## Groundwater Application Review Summary Form

Application # G- 18527

GW Reviewer Phil Marcy Date Review Completed: 4/16/2018

TO: Water Rights Section Date 04/13/2018  
 FROM: Groundwater Section Phillip I. Marcy  
 Reviewer's Name  
 SUBJECT: Application G- 18527 Supersedes review of \_\_\_\_\_  
 Date of Review(s) \_\_\_\_\_

### Cross-section of nearby wells

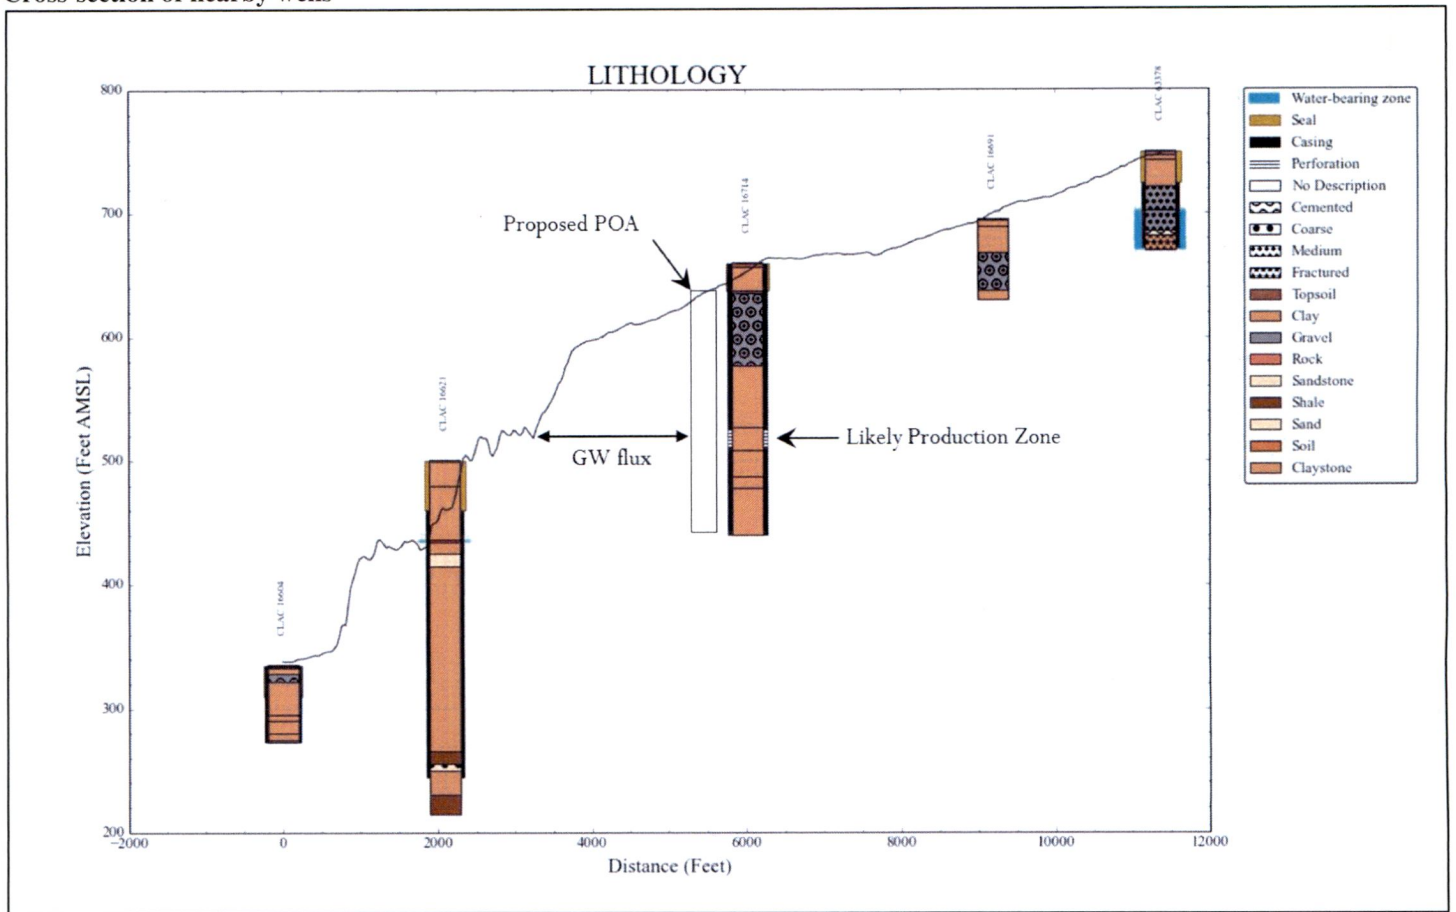
**Basis for aquifer confinement evaluation:** Any confinement provided by overlying fine-grained horizons at this location is highly localized, as the proposed water-bearing and overlying lithologies are incised within 1 mile by the Clackamas River Canyon to the East.

**Basis for aquifer hydraulic connection evaluation:** The water-bearing zone within the proposed POA well would produce from horizons that are incised by local drainages. Thus, groundwater in these horizons discharges where these lithologies are exposed, with little or no barrier to flow.
